June 3, 2022

RE: St. Lucie Plant Units 1 and 2
Dockets 50-335 and 50-389
Renewed Facility Operating Licenses DPR-67 and NPF-16

License Amendment Request, Revision 1 to the Technical Specifications Conversion to NUREG-1432, Revision 5

FIGURE 2.2-1

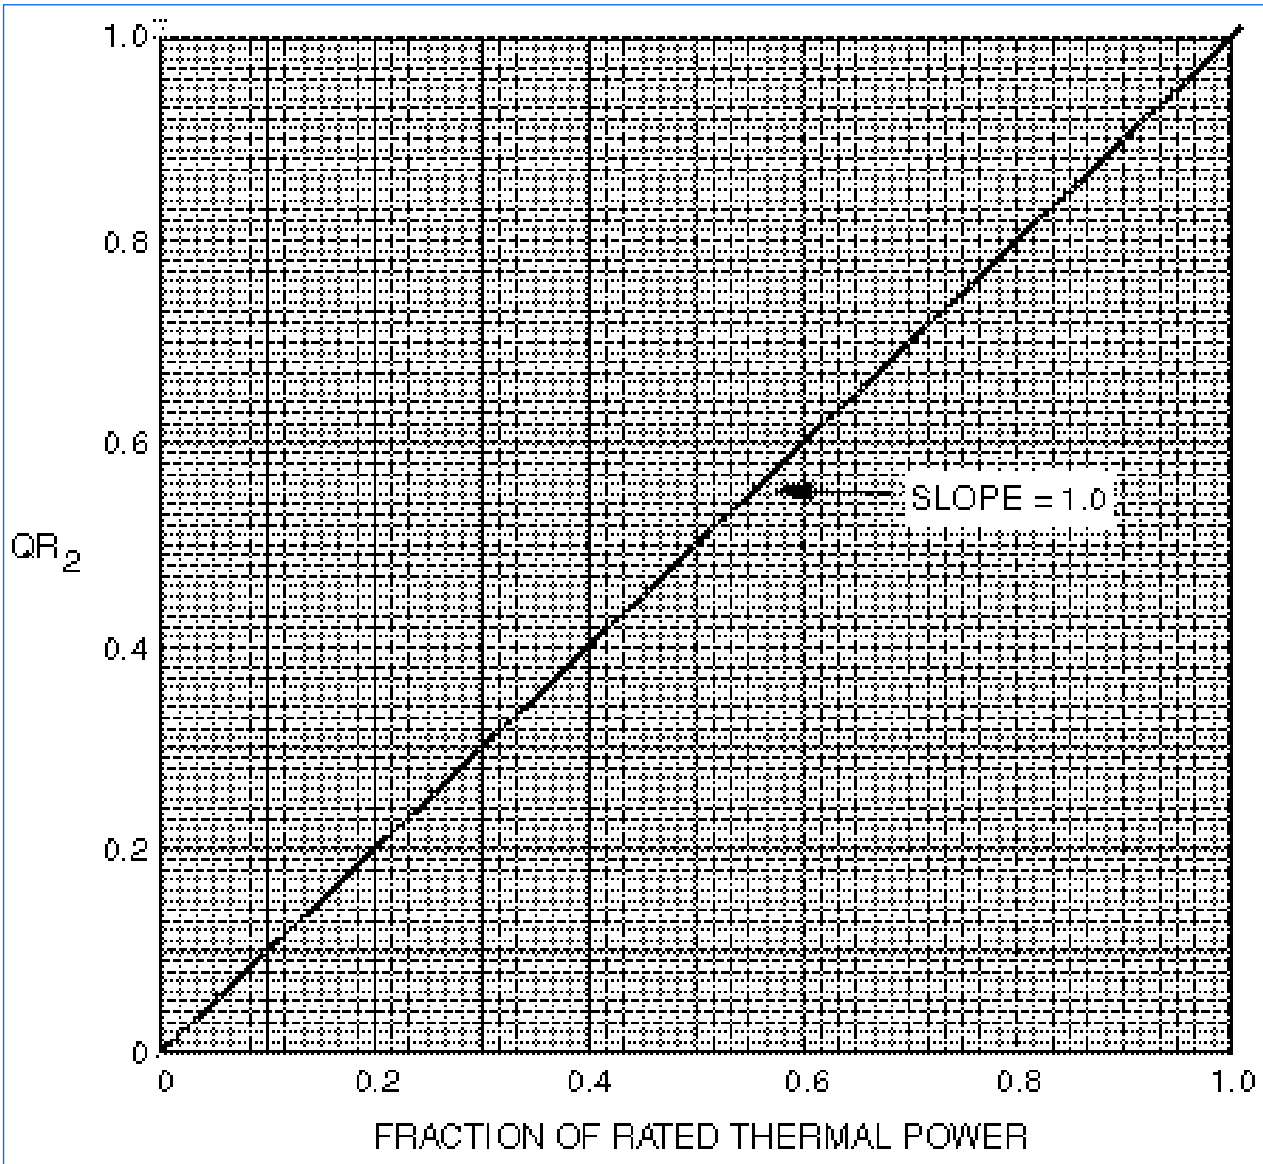
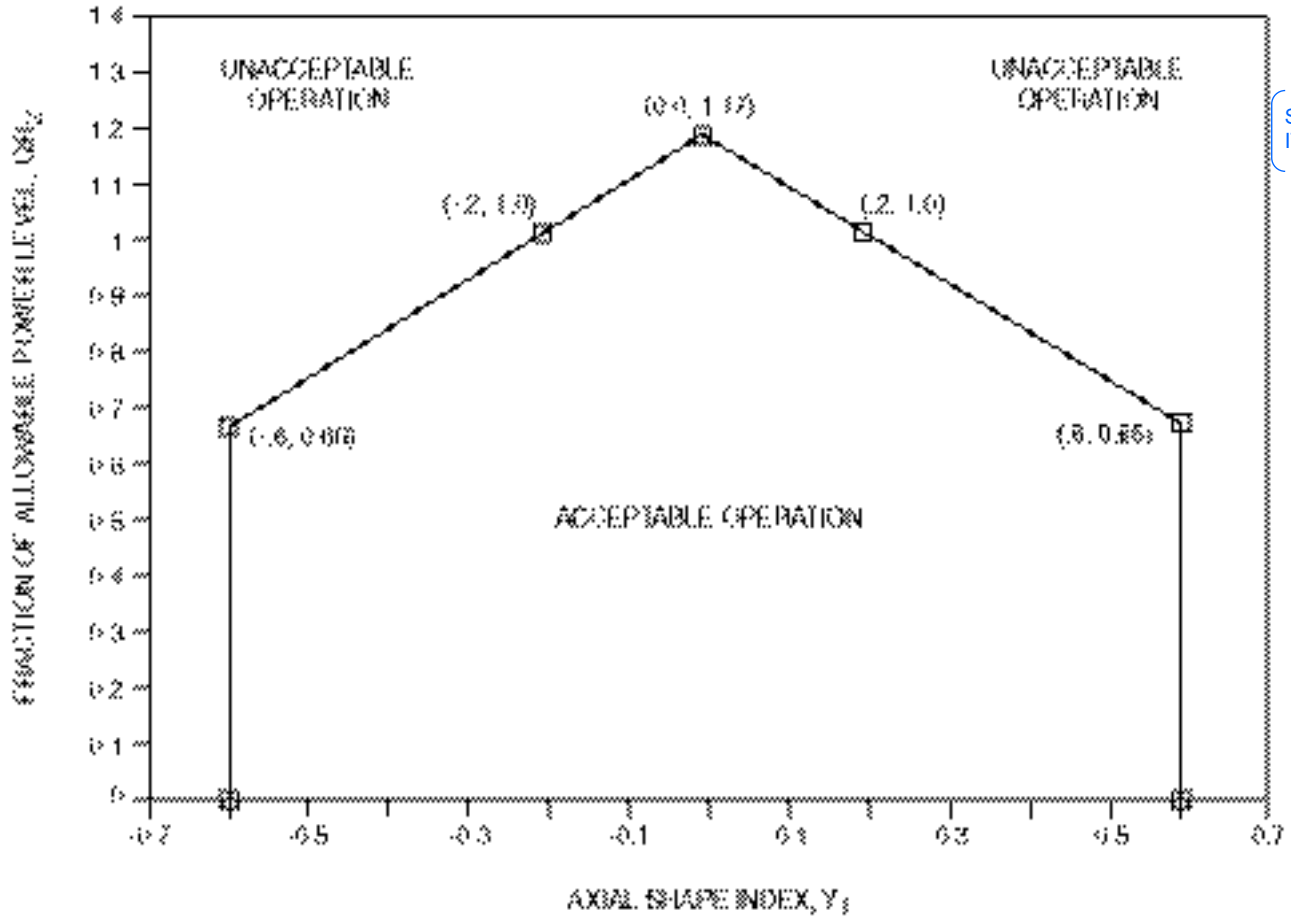
1. On pages 68, 69, 80, and 81/450, Both Units – The ITS say to insert figure 2.2-1, but there does not appear to be adequate space on the page. If another page is added the page

numbering will be incorrect. Also figure 3.3.1-3 on ITS page 3.3.1-12 (taken from CTS figure 2.2-2) is labeled page 1 of 1, but it appears to be page 2 of 2. Figure 2.2-1 appears to be page 1 of 2.

- CTS Figure 2.2-3 will be ITS Figure 3.3.1-1 (Page 1 of 1),
- CTS Figure 2.2-4 will be ITS Figure 3.3.1-2 (Page 1 of 1),
- CTS Figure 2.2-1 will be ITS Figure 3.3.1-3 (Page 1 of 2), and
- CTS Figure 2.2-2 will be ITS Figure 3.3.1-3 (Page 2 of 2).

FIGURE 2.1-1~~:~~ REACTOR CORE THERMAL MARGIN SAFETY LIMIT LINES

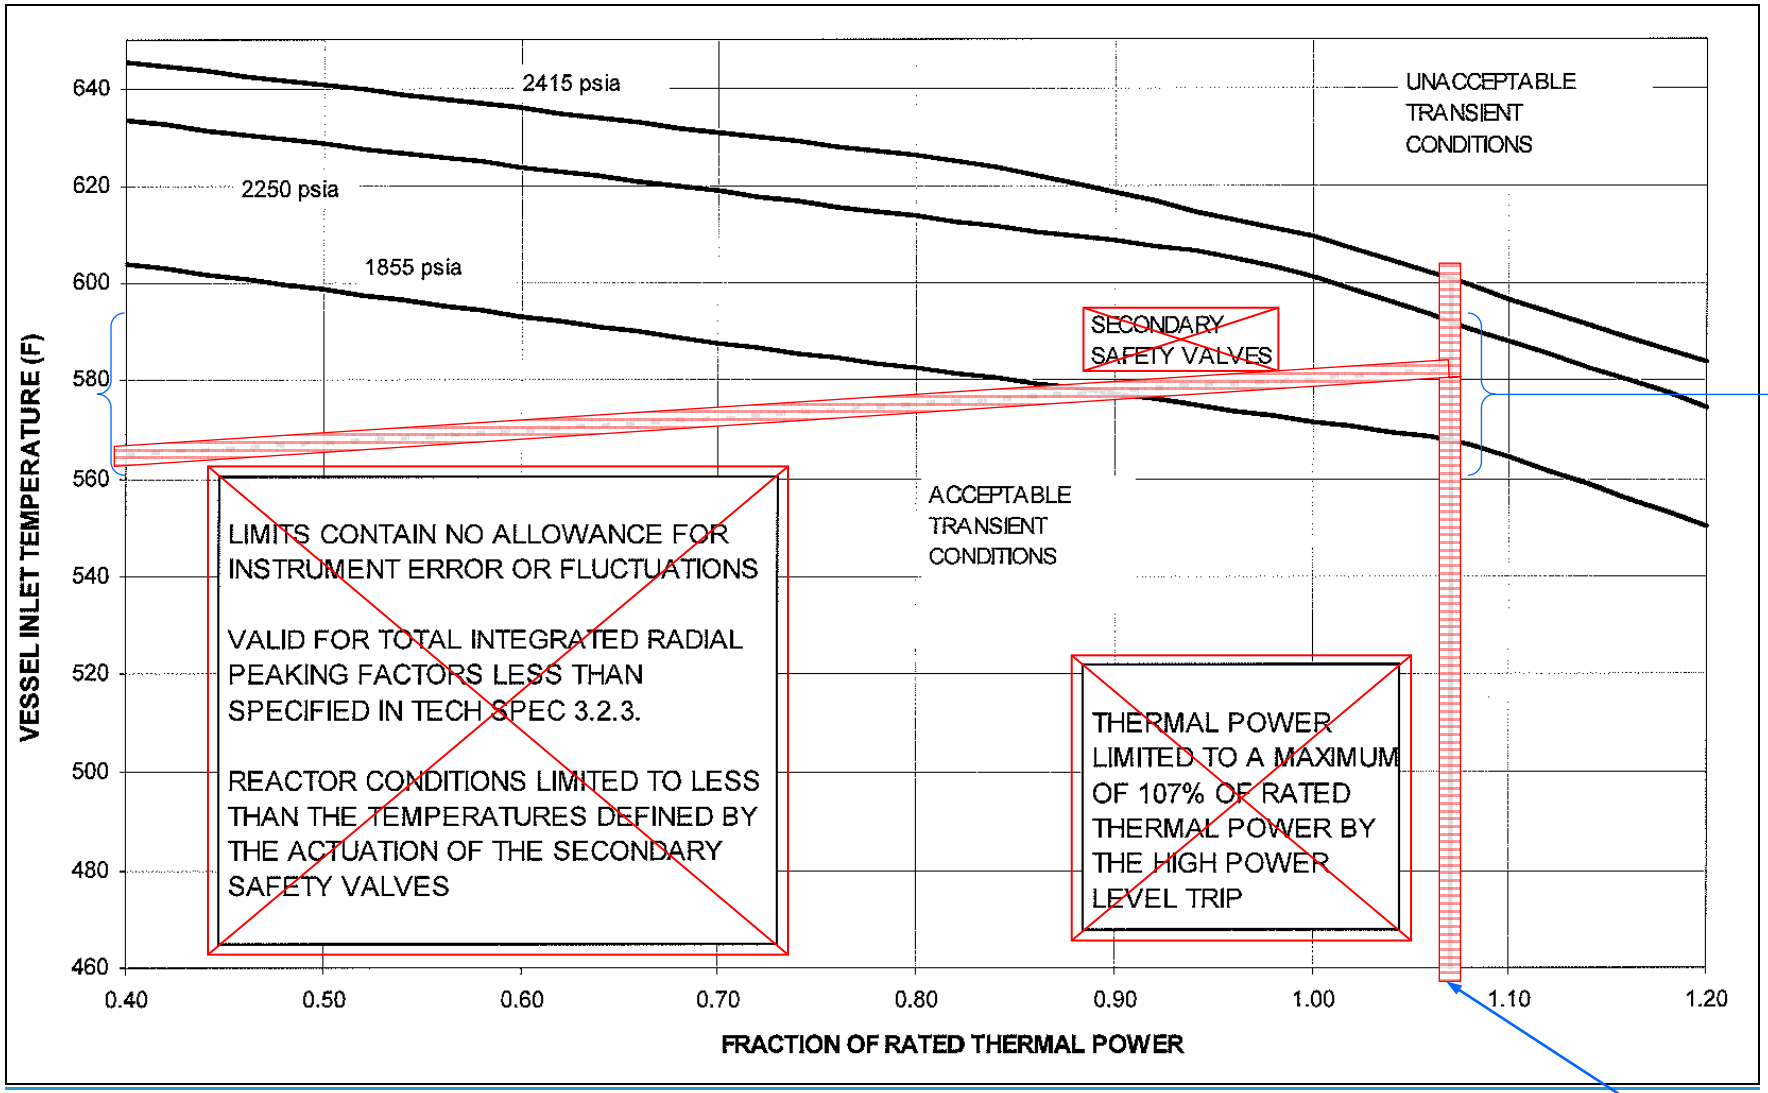
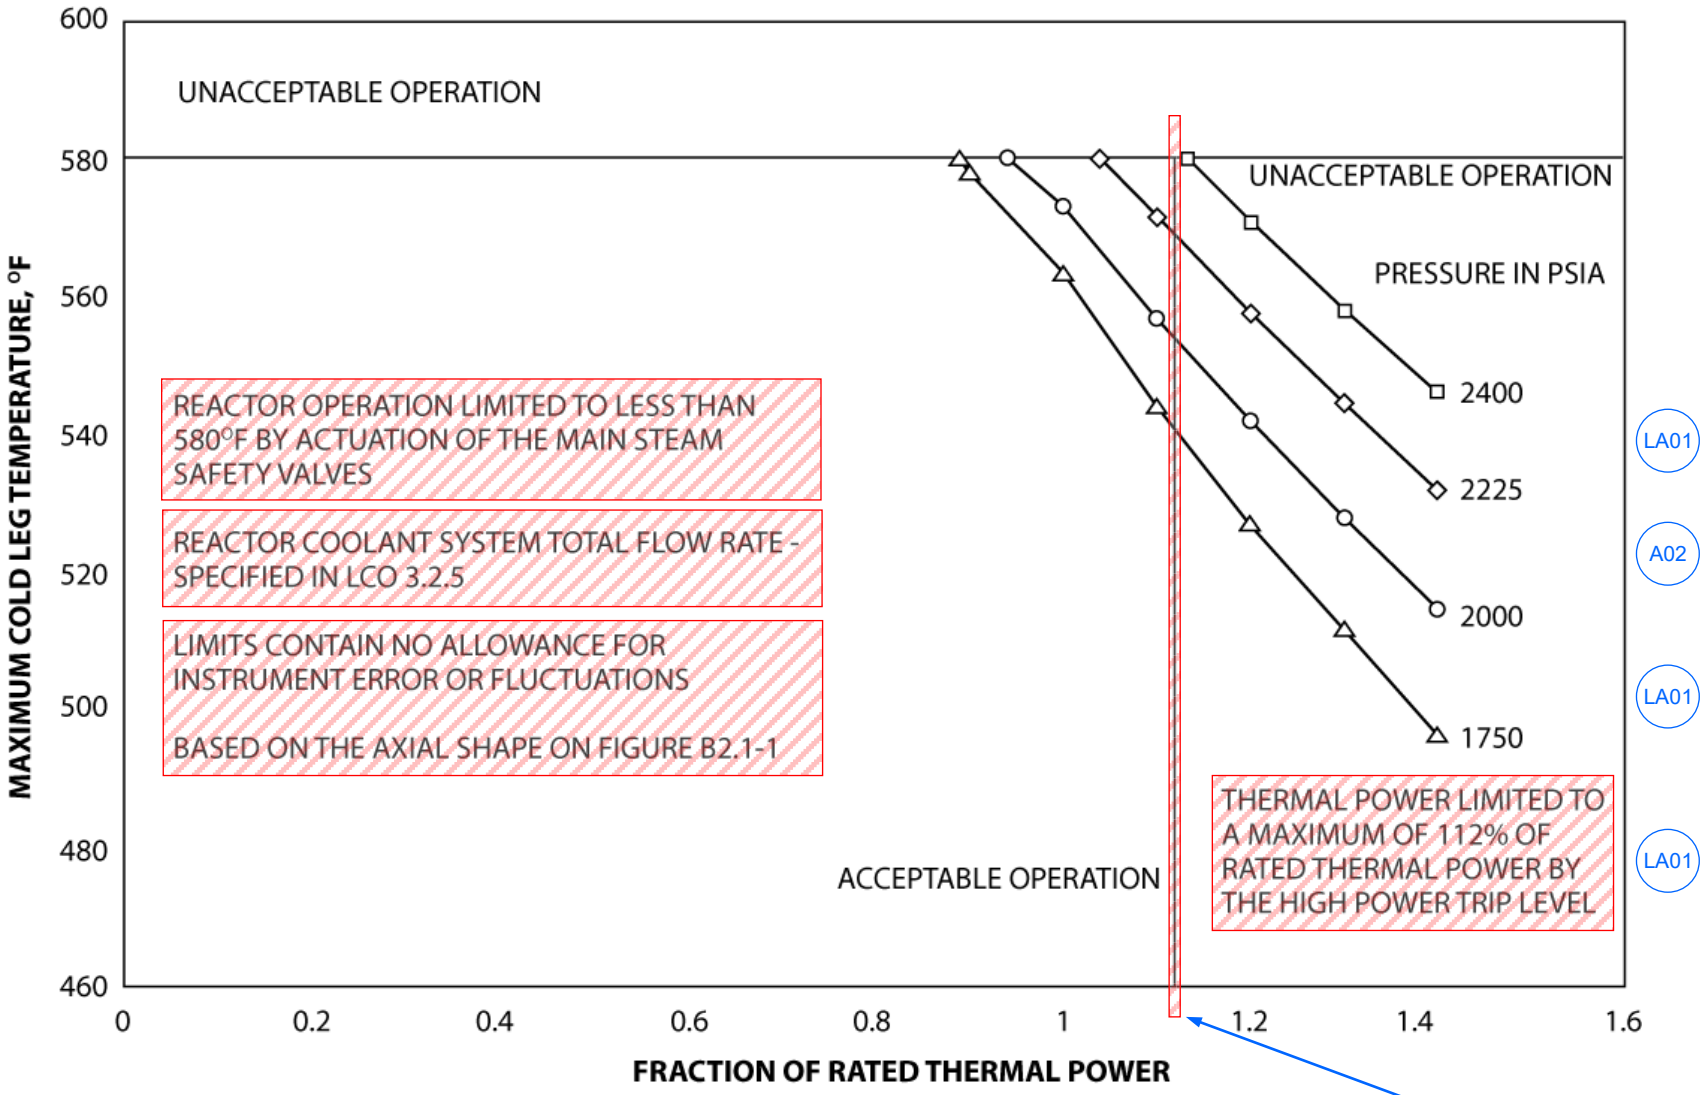
A03 PSL Unit 1 CTS Figure 2.1-1, Reactor Core Thermal Margin Safety Limit – Four Reactor Coolant Pumps Operating contains an operational limit line showing thermal power limited to a maximum of 112% of RATED THERMAL POWER by the High Power Trip. PSL Unit 2 CTS Figure 2.1-1, Reactor Core Thermal Margin Safety Limit – Four Reactor Coolant Pumps Operating contains an operational limit line showing thermal power limited to a maximum of 107% of RATED THERMAL POWER by the High Power Level Trip, and contains an operational limit line showing limits on maximum cold leg temperature due to secondary safety valve actuation. Additionally, the Unit 1 and Unit 2 figure titles include the statement “Four Reactor Coolant Pumps Operating.”

PSL Unit 1 CTS Figure 2.1-1 statements “Reactor operation limited to less than 580°F by actuation of Main Steam Safety Valves”, “Limits contain no allowance for instruments error or fluctuations”, “Based on the Axial Shape Index on Figure B 2.1-1,” and “THERMAL POWER limited to a maximum of 112% of RATED THERMAL POWER by the high power trip level” are moved from the Technical Specifications to the ITS Bases. The line showing THERMAL POWER at 112%

LA01 *(Type 1 – Removing Details of System Design and System Description, Including Design Limits)* CTS 2.1.1 states “The combination of THERMAL POWER, pressurizer pressure, and maximum cold leg coolant temperature shall not exceed the limits shown on Figure 2.1-1.” ITS states “The combination of THERMAL POWER, pressurizer pressure, and the highest operating loop cold leg coolant temperature shall not exceed the limits shown in Figure 2.1.1-1.” This changes the CTS by moving details shown on the CTS Figure 2.1-1 to the ITS Bases.

~~Figure 3.1.3-1 (page 1 of 1)~~
~~Allowable Positive MTC Limit~~

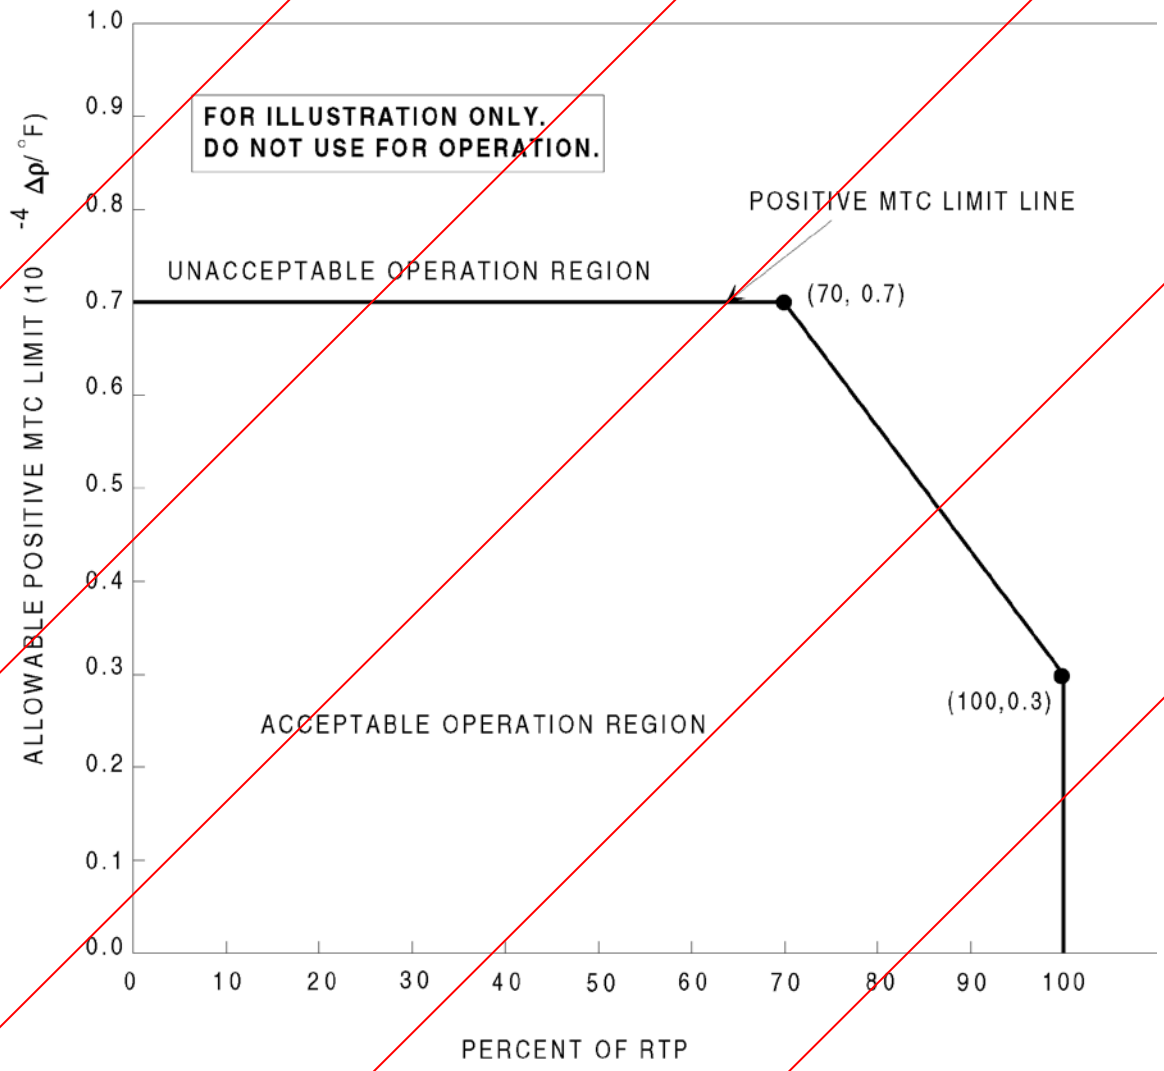
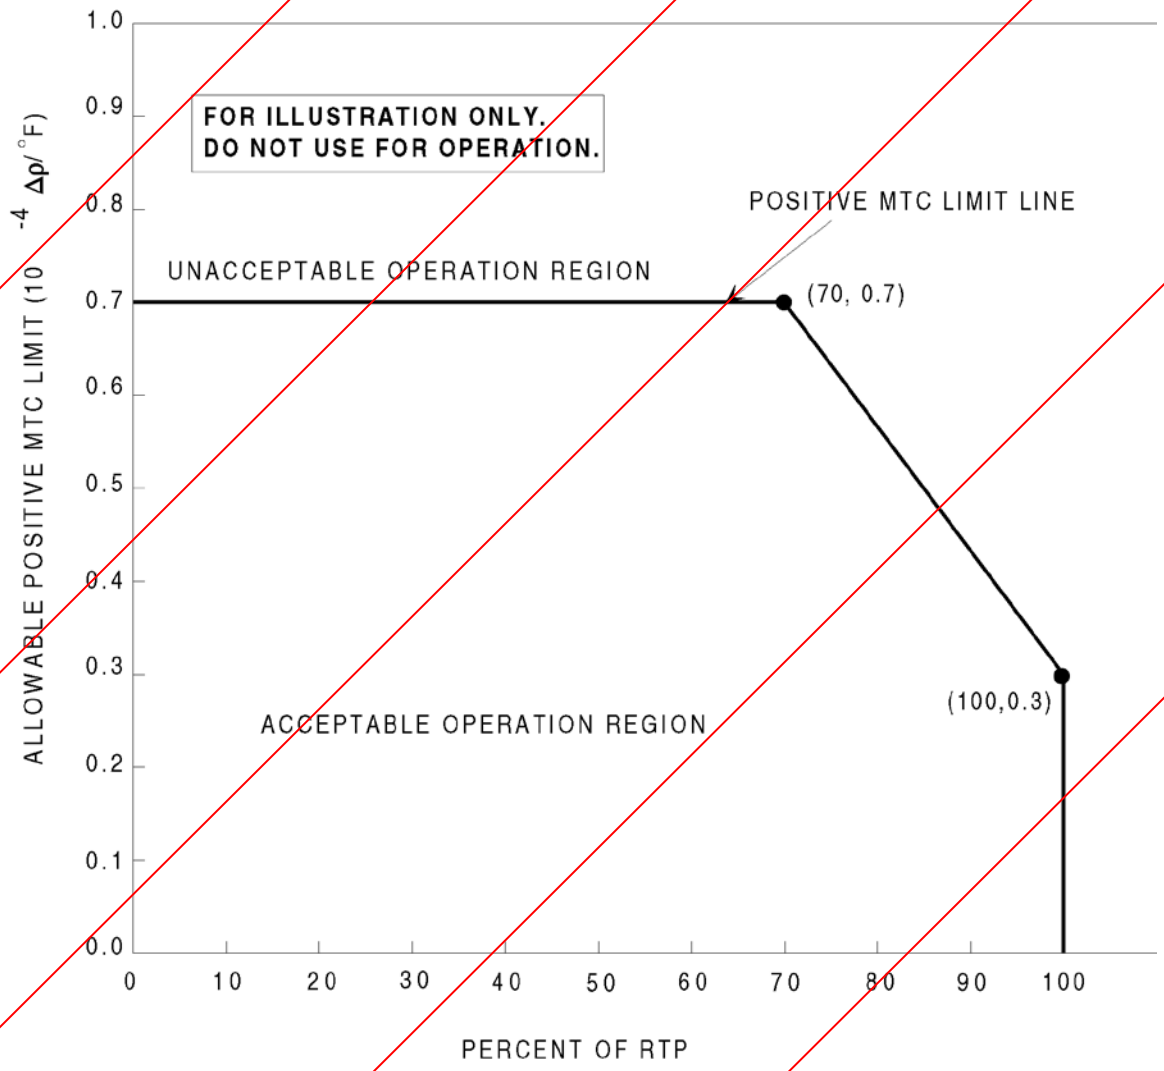
2. ISTS 3.1.3 contains Figure 3.1.3-1 for Allowable Positive MTC Vs Percent of RTP. This figure is not maintained in ITS 3.1.3. ITS 3.1.3 lists the maximum upper limit value based on THERMAL POWER level in the LCO. Therefore, ISTS Figure 3.1.3-1 is not required and has been deleted.
